January 27, 2000
RC-00-0025

Subject: VIRGIL C. SUMMER NUCLEAR STATION
DOCKET NO. 50/395
TECHNICAL SPECIFICATION AMENDMENT REQUEST
TSP 99-0160 - SPENT FUEL POOL - K_{∞}

SCE&G -- EXPLANATION OF CHANGES

SAFETY EVALUATION
FOR REVISING SPENT FUEL STORAGE REQUIREMENTS IN
THE VIRGIL C. SUMMER NUCLEAR STATION
TECHNICAL SPECIFICATIONS

SOUTH CAROLINA ELECTRIC & GAS CO.
VIRGIL C. SUMMER NUCLEAR STATION
Region 1 Minimum
IFBA Requirements
FIGURE 5.6-1

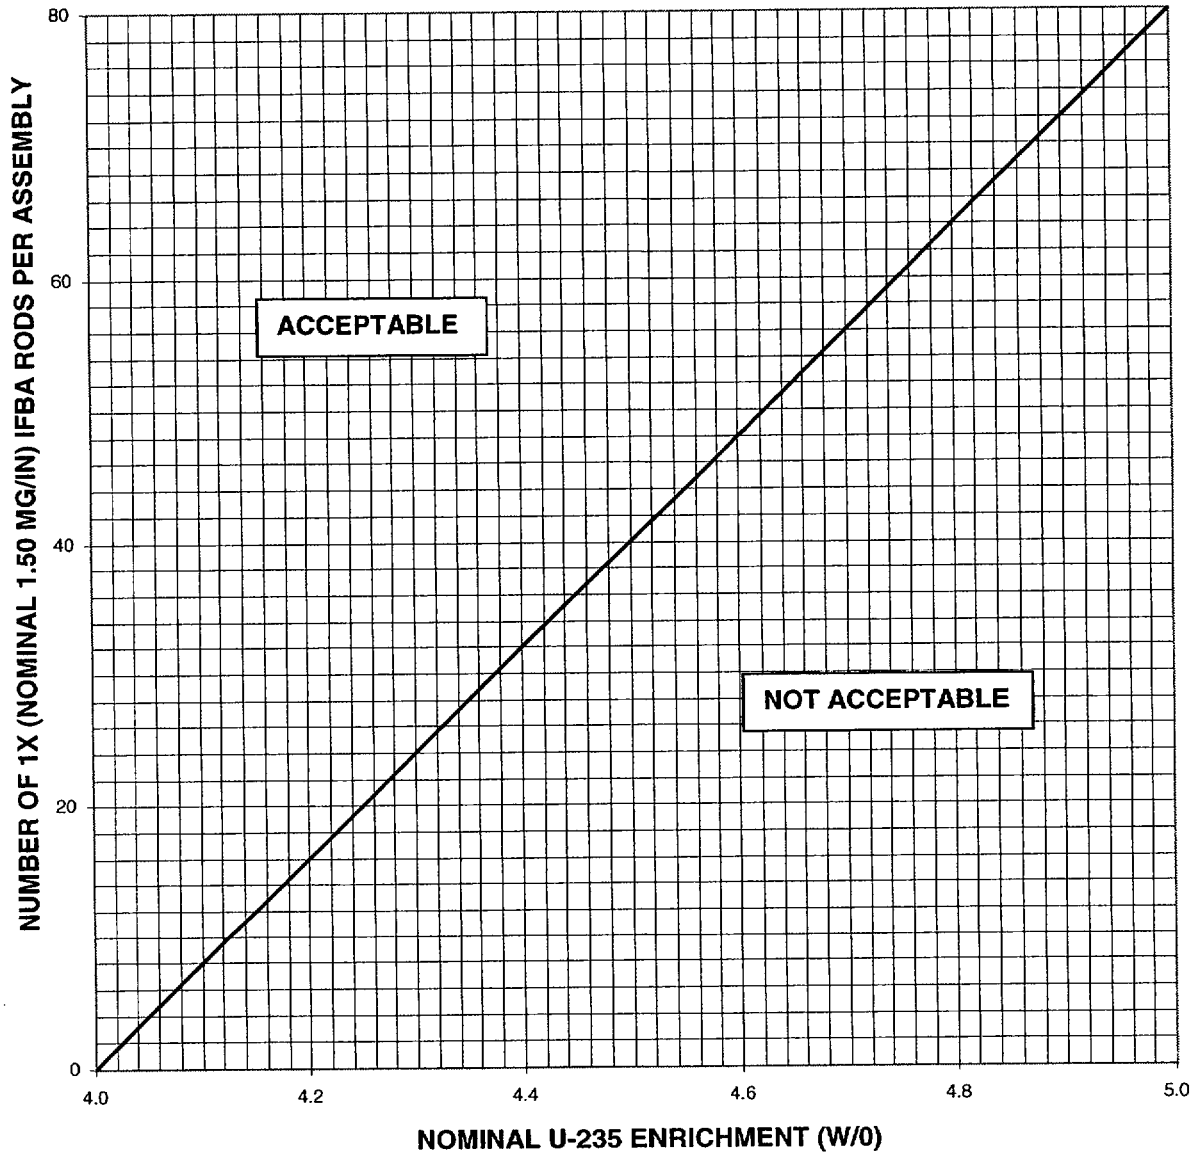
The proposed changes will revise the Spent Fuel Pool reactivity limit requirement by removing the value for K_{∞} from Specification 5.6.1.1 and replacing it with a figure of Integral Fuel Burnable Absorbers (IFBA) rods versus nominal Uranium-235 enrichment. The proposed change will also delete the value for K_{∞} from Specification 5.6.1.2, since IFBA credit is not considered or required in the new fuel storage criticality analysis.

The proposed Technical Specification changes remove the value for K infinity (K_{∞}) from TS 5.6.1.1 and replace it with a figure of IFBA rods per assembly versus nominal Uranium-235 enrichment. The proposed changes also delete the value for K_{∞} in TS 5.6.1.2 since the licensing basis is satisfied without crediting IFBAs.

The K_{∞} method utilizes the reactor configuration rather than the SFP rack configuration. A review of the methods by Westinghouse shows that the K_{∞} method could lead to IFBA requirements which are lower than those required by the IFBA-enrichment curve. Thus, there is the potential for non-conservative IFBA requirements determined using the K_{∞} methodology.

The Integral Fuel Burnable Absorbers (IFBA) rod requirements shown in Figure 5.6-1 are based on a nominal IFBA linear B^{10} loading of 1.50 mg- B^{10} /inch (1.0X). For higher IFBA loadings up to 3.00 mg- B^{10} /inch (2.0X), the required number of IFBA rods may be reduced by the ratio of the increased B^{10} loading to the nominal 1.50 mg- B^{10} /inch loading. The poison length of the IFBA rods is greater than or equal to 108 inches.

2. A nominal enrichment of 5.0 weight percent U-235 with a minimum number of integral fuel burnable absorbers as shown on Figure 5.6-1. The Integral Fuel Burnable Absorbers (IFBA) rod requirements shown in Figure 5.6-1 are based on a nominal IFBA linear B^{10} loading of 1.50 mg- B^{10} /inch (1.0X). For higher IFBA loadings up to 3.00 mg- B^{10} /inch (2.0X), the required number of IFBA rods may be reduced by the ratio of the increased B^{10} loading to the nominal 1.50 mg- B^{10} /inch loading. The poison length of the IFBA rods is greater than or equal to 108 inches.
